NO: CON – 108A
DATE: February 2026

PRODUCT: Misc. XM3, XW4, XG2, XG4 and XJ8
Connectors
TYPE: DISCONTINUATION - PARTIAL

PARTIAL DISCONTINUATION

Misc. XM3, XW4, XG2, XG4 and XJ8 Connectors

Discontinued Product	Suggested Replacements																																														
XJ8B-0241	XG8S-0241

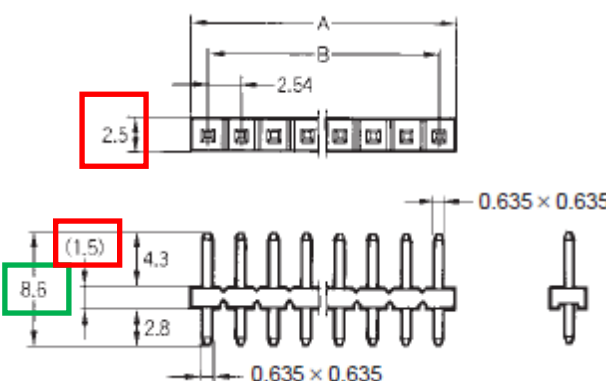
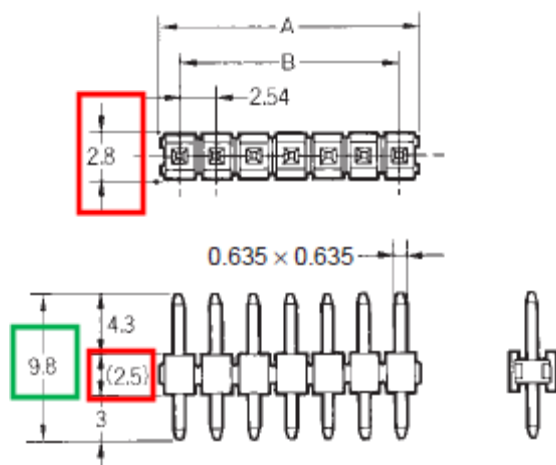
Suggested Replacement Model	Body Color	Dimensions	Wire connection	Mounting Dimensions	Characteristics	Operation ratings	Operation methods
XG8S-0241	**	*	**	**	-	**	**

Red frame: Housing dimensions are different.

Green frame: Pin lengths are different.

** Pin tip heights from the mounting surface (PCB) are different. For XG8S: Housing height 2.5 + pin height 4.3 = 6.8
